NEW MEXICO ENVIRONMENT DEPARTMENT

Re: Gallardo Construction, LLC / Metro Verde South 3C; CGP; SIC 1521; NPDES Compliance Evaluation Inspection; NPDES #NMR100016Q; May 3, 2018

NPDES Compliance Inspection Report

NPDES Construction General Permit Inspection Report – State of New Mexico

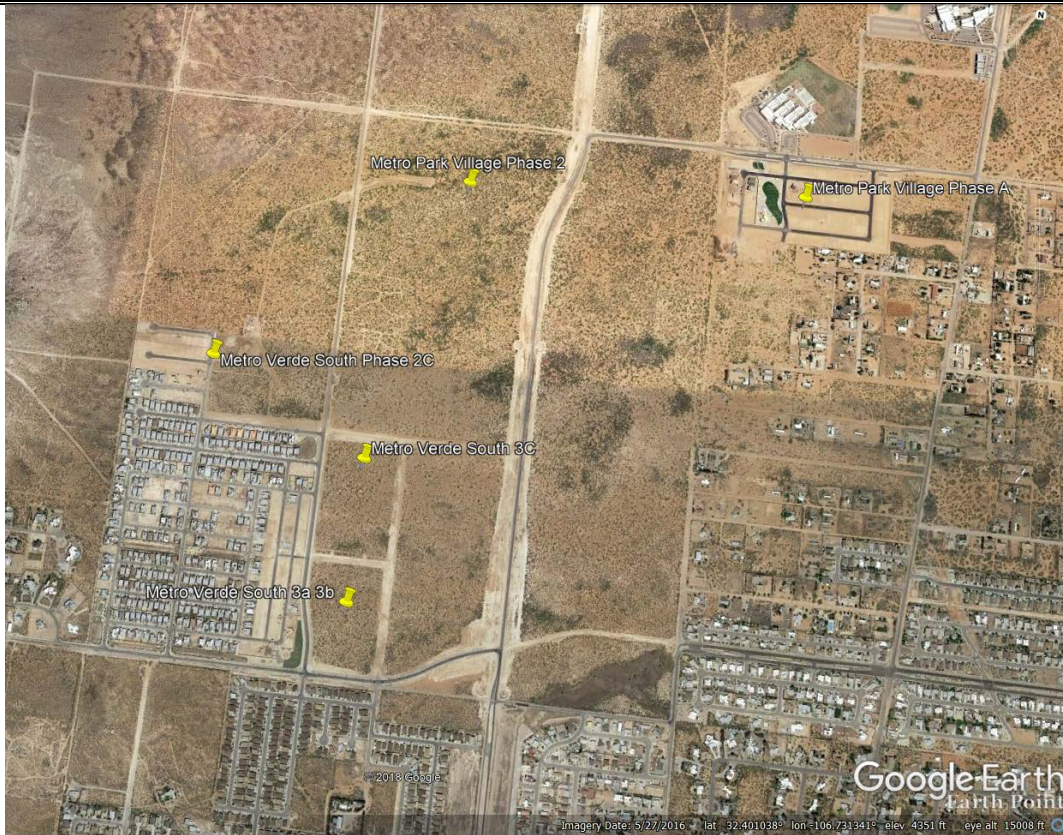
An oil leak was noted where the water truck fills up, but otherwise the site had good housekeeping. No stabilization BMPs have been designed for drainage swales and ponds. In general the housing sites will be transferred to builders, but shared areas must be stabilized. No outlet protection was installed at the ponds. Concrete washouts were utilized.

- Part 2.2.10 Storm drain outlets must be protected.
- Part 2.2.14 No documentation of method of stabilization of disturbed areas.
- Part 2.3.1.f Vehicle leaking oil (See Appendix A: cleaned up later that day)

As soon as you left, I notified our equipment supervisor, Chacho Gallardo, and informed him of water truck leaking fluids. Chacho immediately replaced water truck. Fluids on concrete flooring was cleaned.

Construction on pond commenced the following day after your visit and we corrected the problem a couple of days later since we had to expose the pipe first in order to place electrical lines. We had the pipe protected at all times to prevent any dirt being drawn into the City of Las Cruces Drainage.

- Part 2.2.10 Storm drain outlets must be protected. Response: The drain outlets were protected during electrical line placement by Gallardo Const. See Appendix A of the NMR1000UH inspection attached.

- Part 2.2.14 No documentation of method of stabilization of disturbed areas. Response: Clarified in para. 10.2 of the SWPP.
- Part 2.3.1.f Vehicle leaking oil. Response: Cleaned up later that day by Gallardo Const.: See Appendix A of the NMR1000UH inspection attached.
